4 Consideration of community submissions

5.1.2 White Bay Station location and rail alignment

Figure 5.1 Alternative alignments at White Bay Station

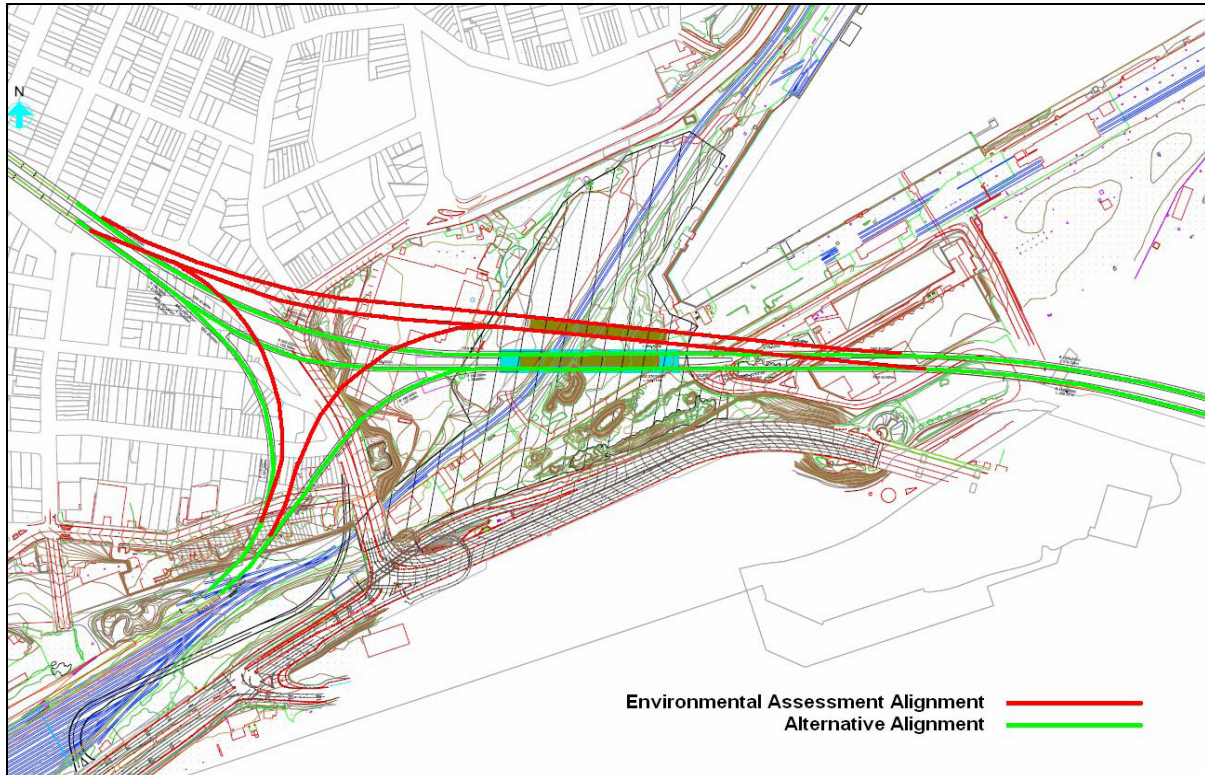
The proposed rail alignment and associated location of the White Bay Station box, as described in section 6.4.7 and shown in Figure 7.12 of the Environmental Assessment, has been amended. The new preferred horizontal alignment of the White Bay Station box would be approximately 25 to 50 metres further south than the location described in the Environmental Assessment (refer Figure 5.1).

The amendment is primarily due to new geotechnical borehole data and the consequential re-assessment of the ground conditions at the White Bay Power Station. Additional geotechnical investigations conducted along the Sydney Metro Network Stage 1 (Central to Rozelle) alignment have shown that the ground conditions beneath the power station and the proposed areas of excavation surrounding the White Bay Station, comprise poor, soft ground material extending to depths of RL-16m AHD or greater and contain the remnants of timber piles used in the construction of the power station. These conditions pose significant program and safety risks as it would not be possible to support the soft, water logged material without high risks to construction workers. As a result, an alternative alignment has been developed to avoid the soft ground where possible.

Figure 5.2 White Bay Station box and alignment changes

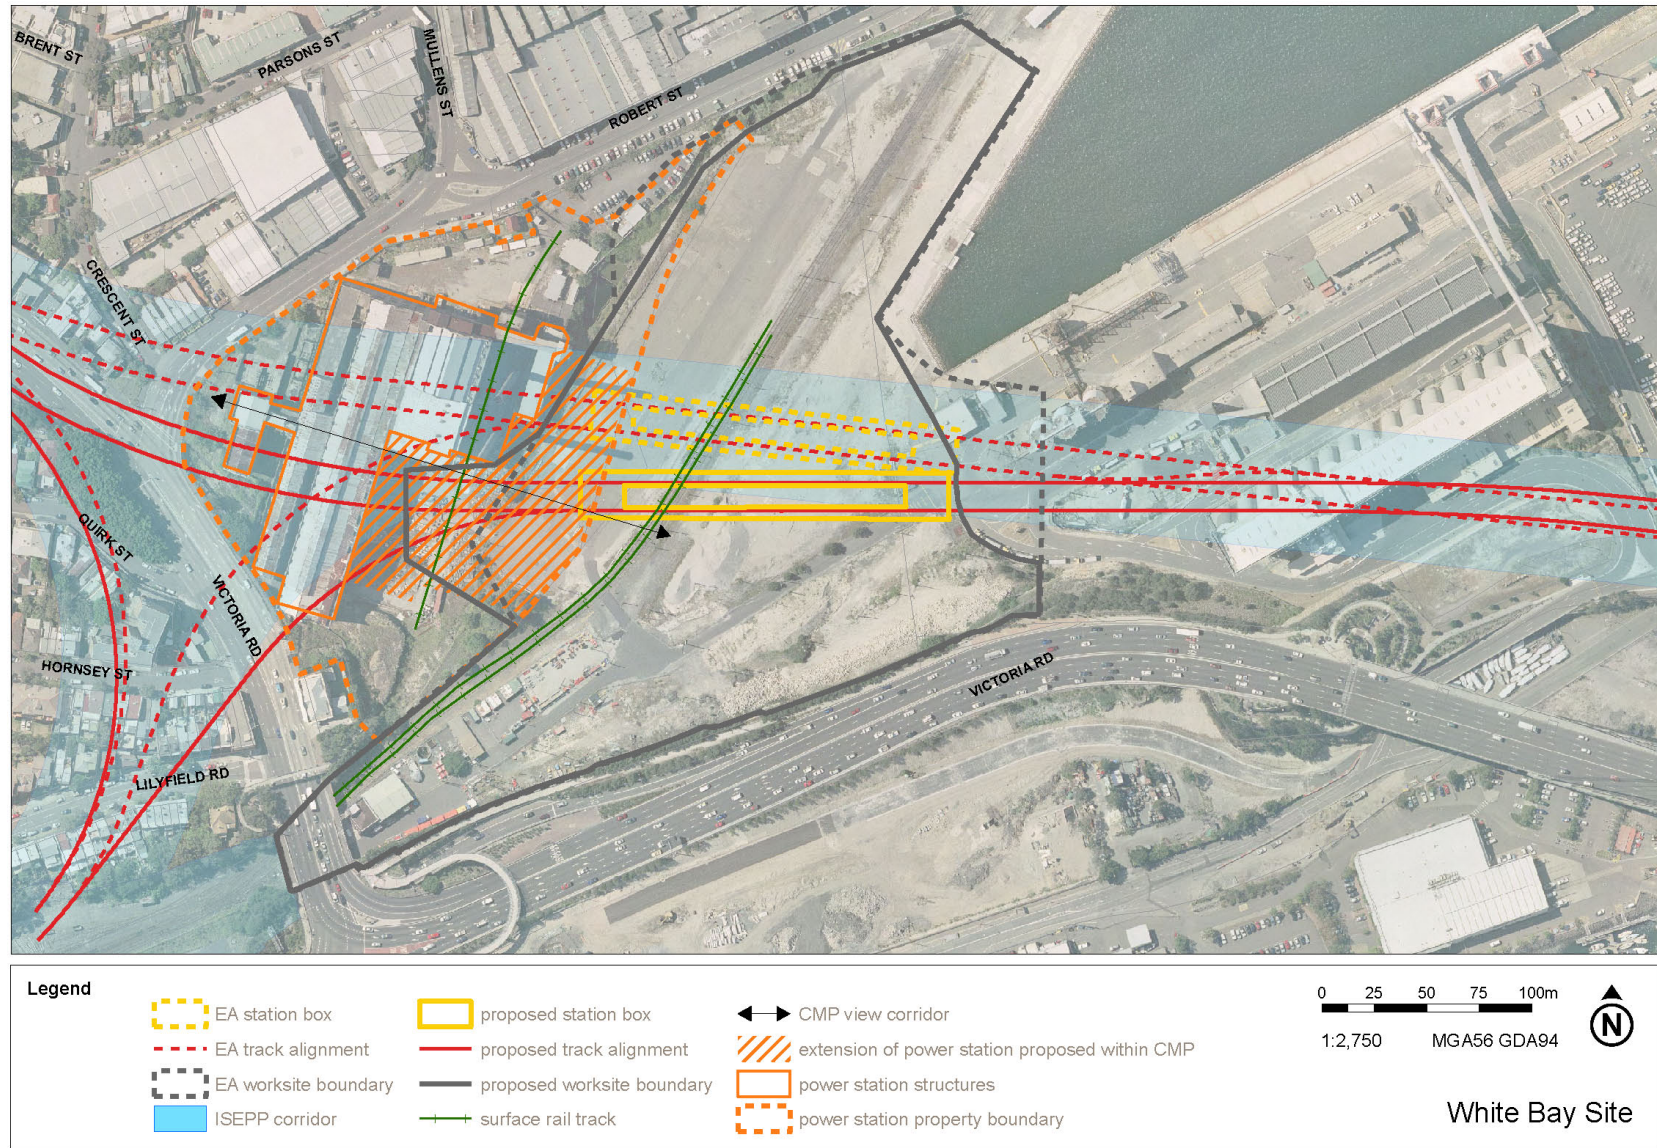
Further detail regarding the design changes at White Bay and the surrounding features affected by the station is shown in Figure 5.2.

The re-positioning of the station box would require the alignment to move outside of the State Environmental Planning Policy (Infrastructure) 2007 (ISEPP) interim corridor in the vicinity of the White Bay Station box (as shown in Figure 5.2). This would affect additional industrial land at White Bay. No additional residential land outside the interim corridor would be affected. The construction zone would also need to extend to the western boundary adjacent to the power station, thereby temporarily affecting the lands owned and managed by Sydney Harbour Foreshore Authority.

In the revised design the station box would be moved approximately 25 to 50 metres south. No movement of the station box west would be required, However the extended construction zone for the cut-and-cover construction of the turn-out to the stabling yard would extend into the power station curtilage by approximately 35 metres further than the previous reference design. These changes are shown in Figure 5.2.
